SB Number:	SB 2DA-006	Creation Date: 20/04/2005
Subject:	Reinforcing fixation of fulcrum pin for strap left cover	
Model:	KM-1650 / 2050 /2550

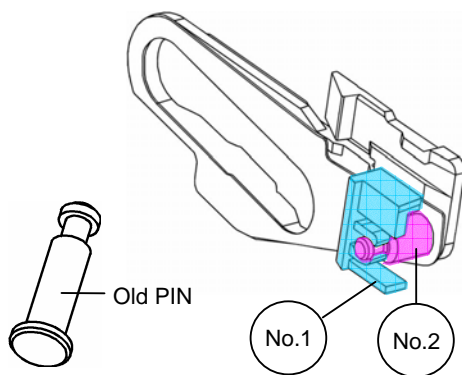
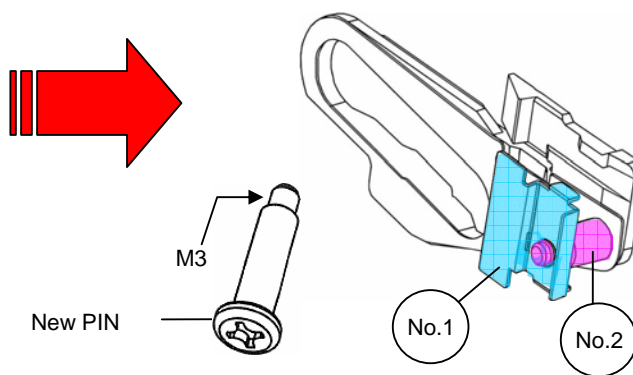
Presently the fulcrum pin (No.2) is fitted into the 'PLATE FRONT STRAP' (No.1 old parts) which is made of resin. To reinforce the fixation of the fulcrum pin, the fulcrum pin (No.2) is changed to screw type. By changing the type of fulcrum pin, the screw type of new fulcrum pin (No.2) is secured on the 'PLATE FRONT STRAP B' (No.1 new parts) which is made of metal.

Fulcrum pin (No.2) is fitted into 'PLATE FRONT STRAP' (No.1 old parts).

The screw type of the new fulcrum pin (No.2) is secured on 'PLATE FRONT STRAP B' (No.1 new parts).

When replacing old with new parts, please replace No. 1 through 2 at the same time
